Access Compliance Report Public Rights-of-Way (Curb Ramps)

Main Street: SOMMERVILLE_PL Cross Street: SLEEPY_HOLLOW_LN Location: SE

ADA ID: RPRK211021134342 Ramp Type: Type 4 - Parallel Initial Pass/Fail: Fail Overall Compliance: No Severity Score: 15

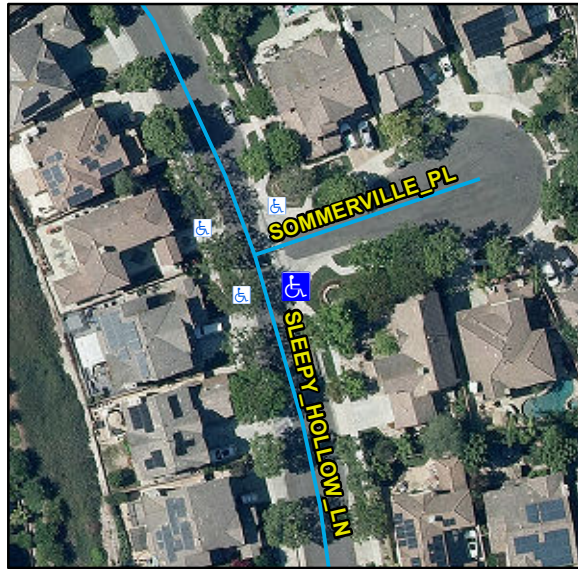
Compliance	Description	Data	Compliance	Description	Data
N/A	Ramp Length LT (in)	114	N/A	Ramp Length RT (in)	120
Yes	Ramp Width LT (in)	54	Yes	Ramp Width RT (in)	54
No	Ramp Run Slope LT (%)	8.7	Yes	Ramp Run Slope RT (%)	2.6
Yes	Ramp Cross Slope LT (%)	0	Yes	Ramp Cross Slope RT (%)	1.7
N/A	Landing Present	N/A	N/A	DWS Provided	N/A
N/A	Landing Length (in)	N/A	N/A	DWS Contrast	N/A
N/A	Landing Width (in)	N/A	N/A	DWS Length (in)	N/A
N/A	Landing Run Slope (%)	N/A	N/A	DWS Full Width	N/A
N/A	Landing Cross Slope (%)	N/A		DWS Offset Type	N/A
N/A	Landing Movement Obstructed?	N/A	N/A	DWS Offset Left (in)	N/A
	Landing Movement Type	N/A	N/A	DWS Offset Right (in)	N/A
N/A	Landing Shared	N/A			
N/A	Clear Space	Yes			
N/A	Clear Space To Crosswalk (in)	N/A			
N/A	Marked Crosswalk 1	No	N/A	Marked Crosswalk 2	No
	Crossing 1 Direction	N		Crossing 2 Direction	W
N/A	Marked Crosswalk 1 Width (in)	N/A		Marked Crosswalk 2 Width (in)	N/A

Remove & Replace Curb Ramp With Two New Directional Ramps or Equivalent.
